10/761,655

Jiun-Nan Chen

Office Action Summary

DETAILED ACTION

FIG. 3a

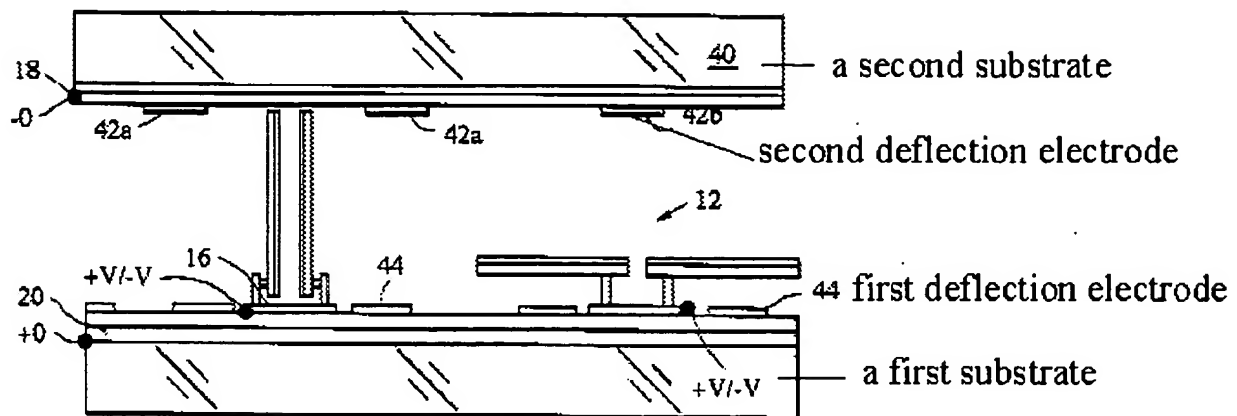
a) With respect to claims 4, 11, 12, 15 and 16, Little et al. disclose apparatus of a bistable paper white direct view display and further with method for providing and imposing in Figure 3a comprising of a plurality of first substrate (not numbered, bottom substrate) having a first surface; a plurality of first deflection electrode formed at least partially on the first surface of the first substrate; a plurality of deflectable elements supported at only one end (see Fig. 5a and 5b) thereof and connected to the first surface of the first substrate and registered with the plurality of first deflection electrodes; a second substrate (item 40) assembled and spaced opposite the first surface of the first substrate, the second substrate having formed therein a plurality of second deflection electrodes registered singly with the deflectable element and plurality of first deflection electrodes such that a deflectable element is physically constrained between a first deflection electrode and a second deflection electrode(see below figure).

FIG. 5a

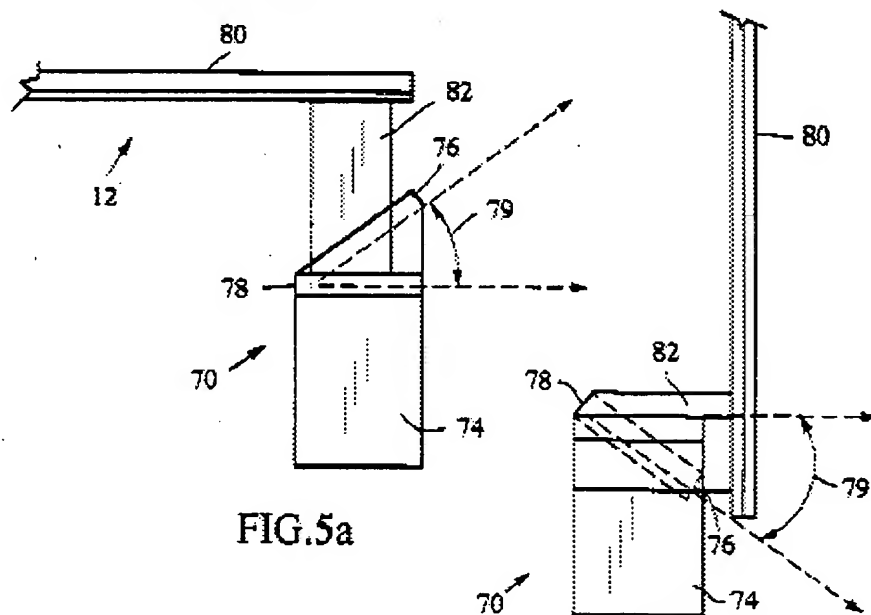
substrate; a deflectable element connected to the first surface of the first substrate and registered with the first deflection electrode; a second substrate assembled and spaced opposite the first surface of the first substrate, the second substrate having formed therein a second deflection electrode registered with the deflectable element (see below figure).

However, Little et al. does not disclose the first deflection electrode is a transparent electrode. Within the same field of endeavor, Atobe et al. disclose in Figure 3B wherein the first electrode is a transparent electrode (made of substance such as ITO).
